Re: Case No. 2010-00083

APPLICATION OF EAST KENTUCKY POWER)	
COOPERATIVE, INC. FOR APPROVAL OF AN)	CASE NO.
AMENDMENT TO ITS ENVIRONMENTAL)	2010-00083
COMPLIANCE PLAN AND ENVIRONMENTAL)	
SURCHARGE)

**RESPONSE TO COMMISSION STAFF'S FIRST DATA REQUEST
TO EAST KENTUCKY POWER COOPERATIVE, INC.
DATED APRIL 29, 2010**

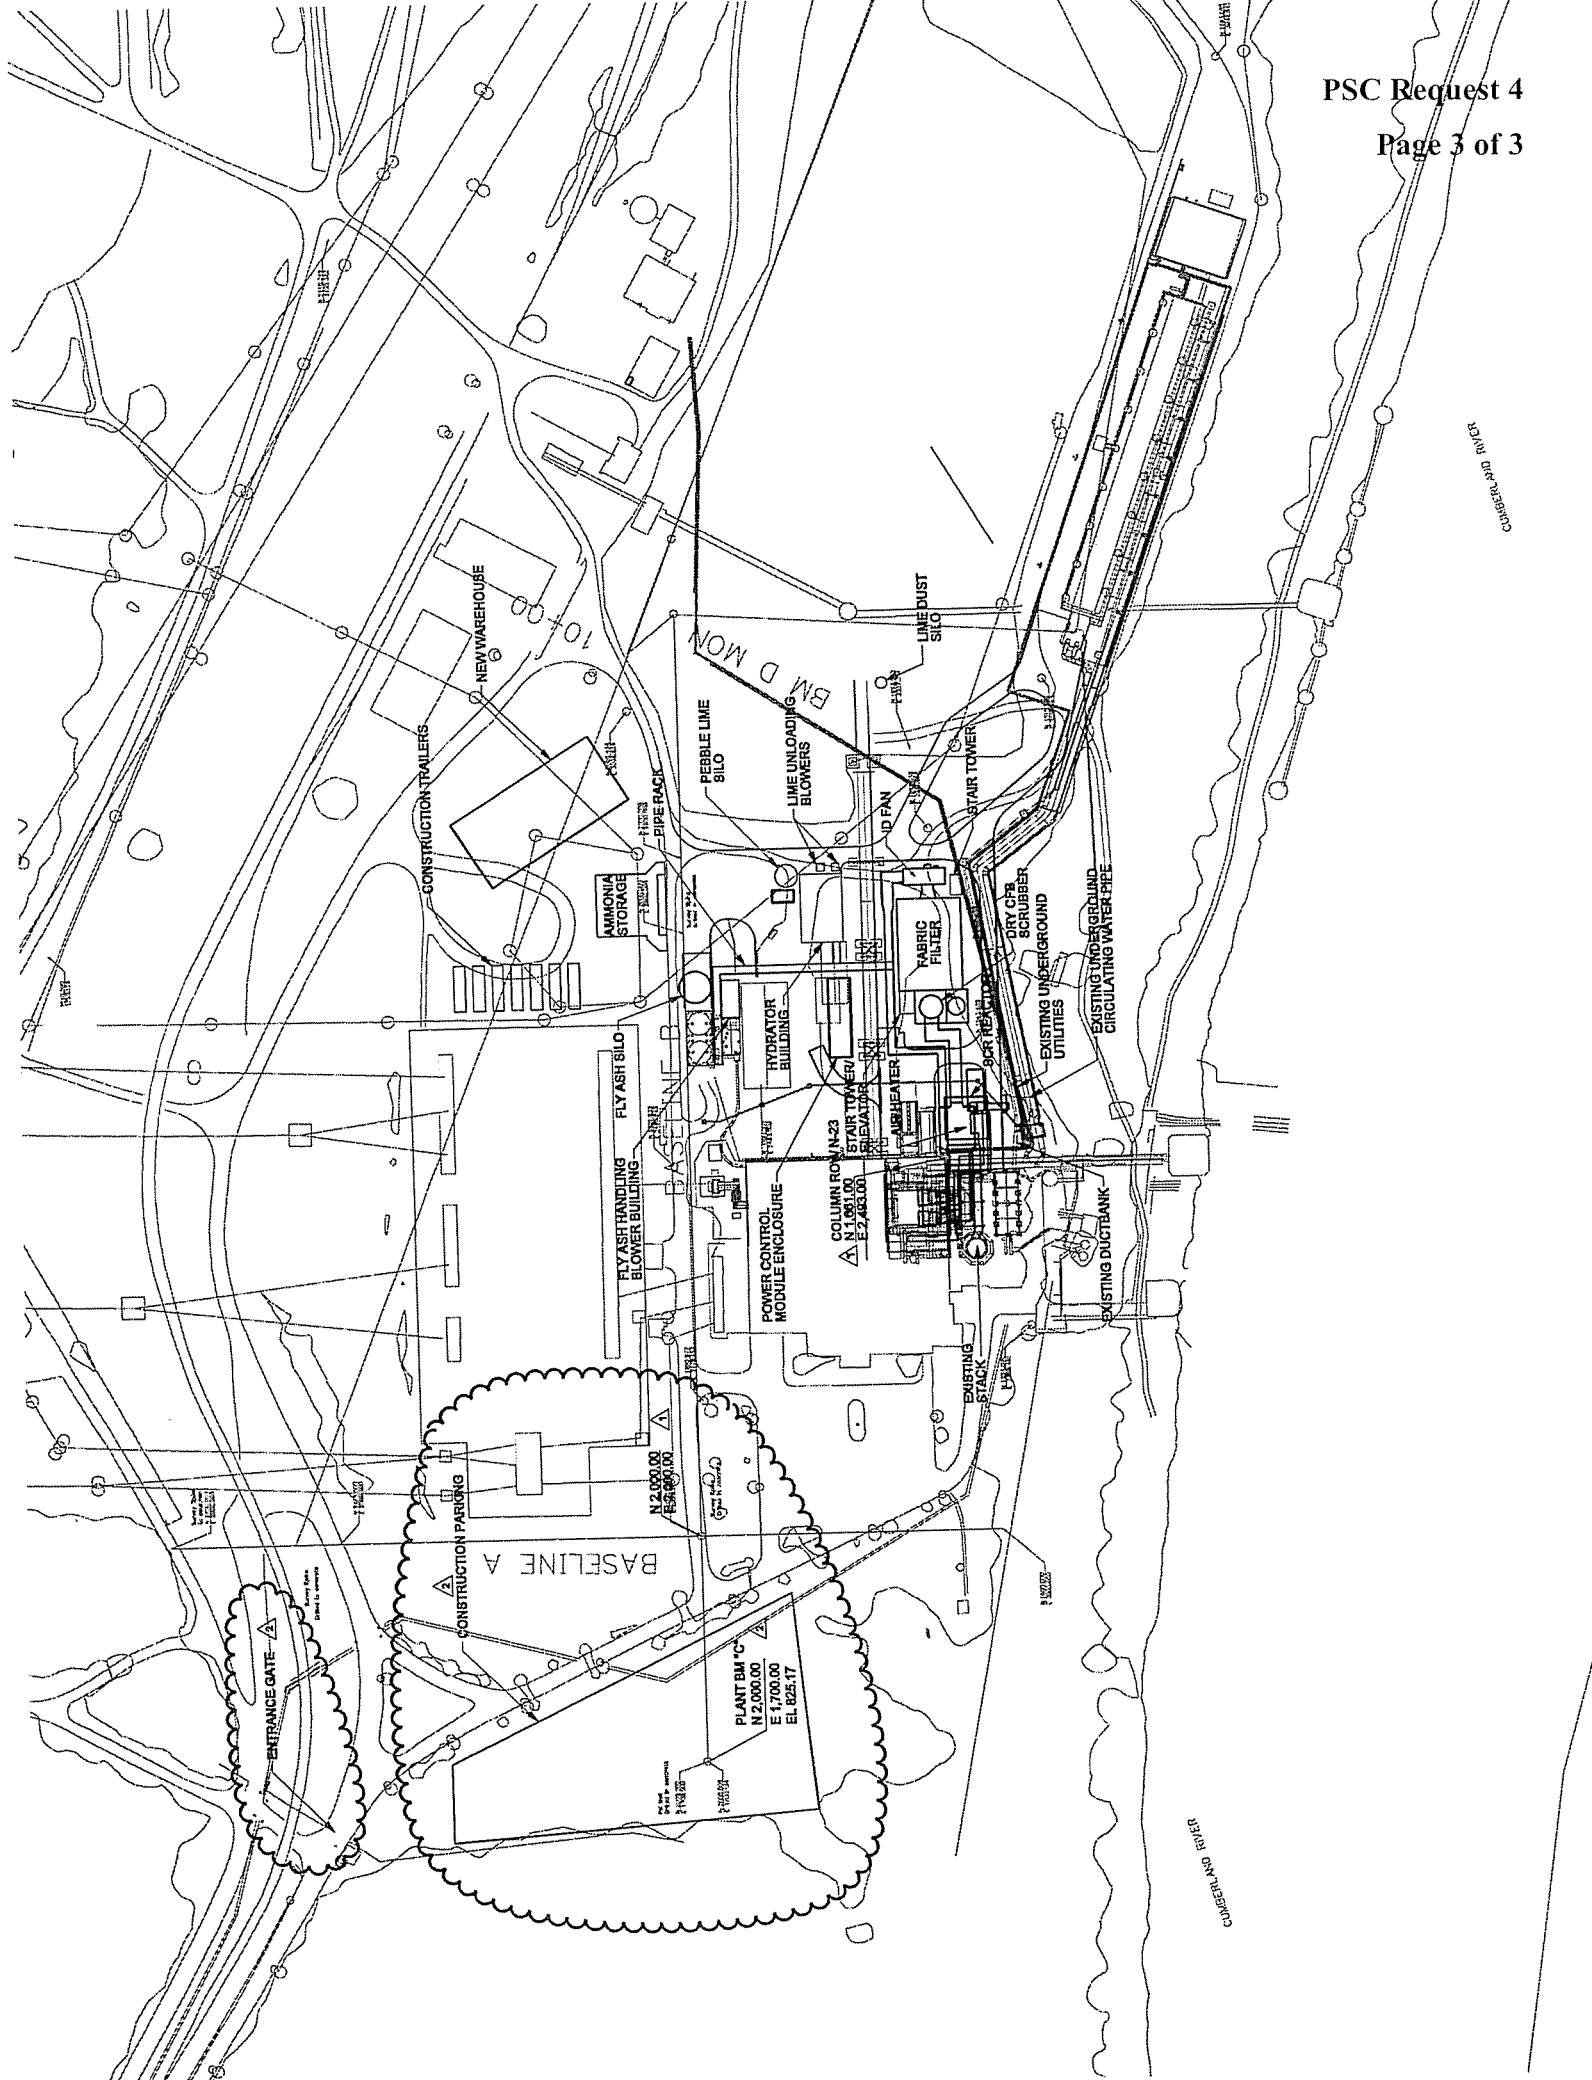
Request 4. Refer to the Wood Testimony, page 3, and Wood Exhibit AFW-3, page 1 of 3. Provide any schematic or cross-section drawing showing the location of the improvements or new project work relative to the other major components of the respective units listed.

Response 4. The diagram for Spurlock Station is provided on page 2 of this response. The diagram for Cooper Station is provided on page 3 of this response.

**EAST KENTUCKY POWER COOPERATIVE, INC.
SPURLOCK STATION LANDFILL
MASON COUNTY, KENTUCKY**

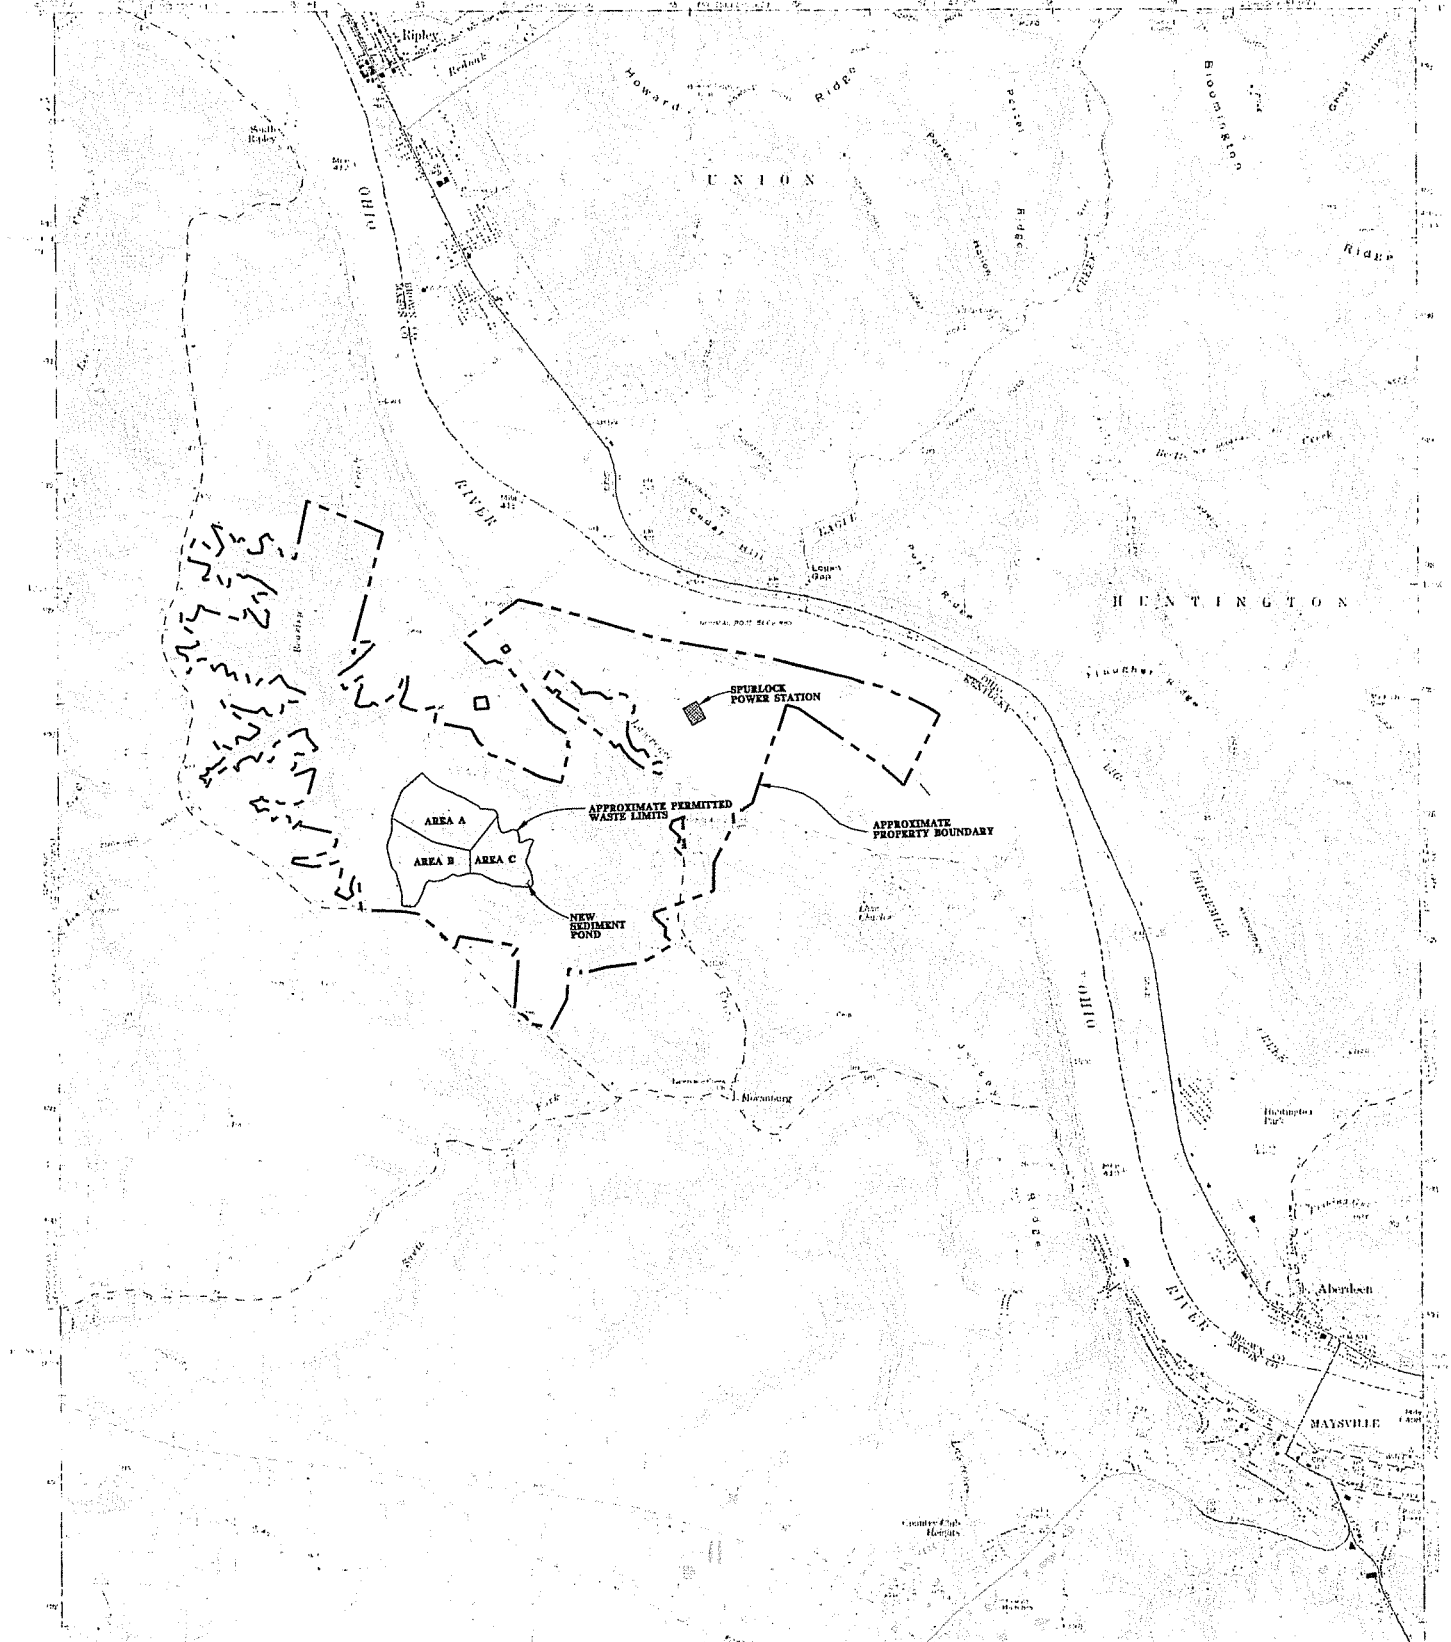
Request 8. Regarding Project 12 - Spurlock Landfill Area C Expansion and Sediment Pond Construction, provide a map showing the location of the landfill and sediment pond and their relationship to the generating plant and surrounding area.

Response 8. Please see the diagram on page 2 of this response.
